Planning App Ref:	PL/2025/09902
Service Ref:	Drainage
Date:	10/03/2026

Discharge of Conditions application

Discharge of Condition 4 (surface water drainage strategy) & 5 (locations of bat roosts and nesting opportunities for birds (e.g. bat and bird boxes) of PL/2025/06520

Woodborough House, Church Farm Lane, Woodborough, Pewsey, SN9 5PL

Figure 1

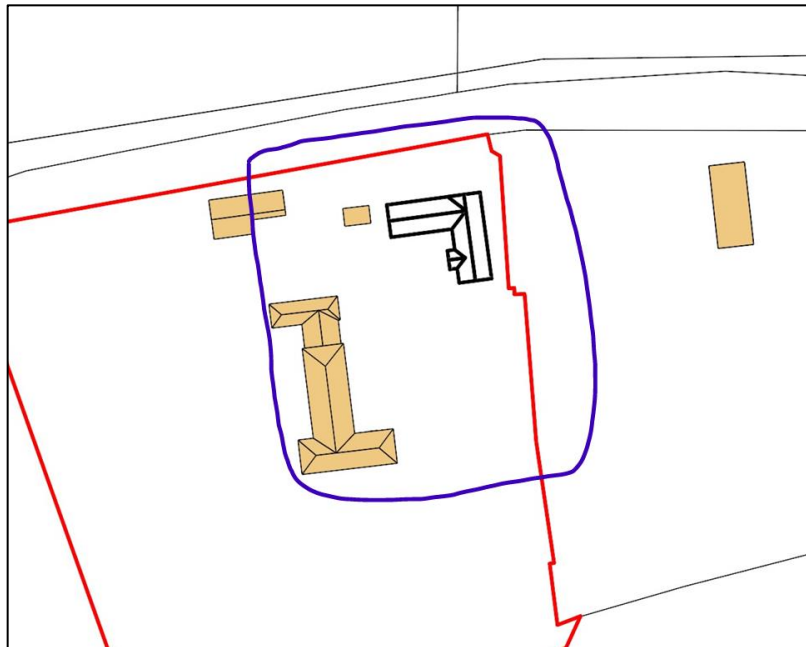
- It is noted that the applicant has considered a factor of safety in the infiltration rate as mentioned in “Surface Water Drainage Engineering Report – Revised”. However, the applicant is required to clearly demonstrate how this has been applied within the calculations (refer Standard 3 [National Standards for SuDS](#)).
- The applicant is required to specify when the infiltration test was undertaken.
- The applicant must provide additional exceedance flow detail, it's noted in drawing Drg No. REV 01 general exceedance flow direction is provided, however the applicant must demonstrate the proposed annex will not indirectly divert flows across either boundary. The applicant should provide several flow arrows in the shaded square in the snip below (refer Standard 3 [National Standards for SuDS](#)).
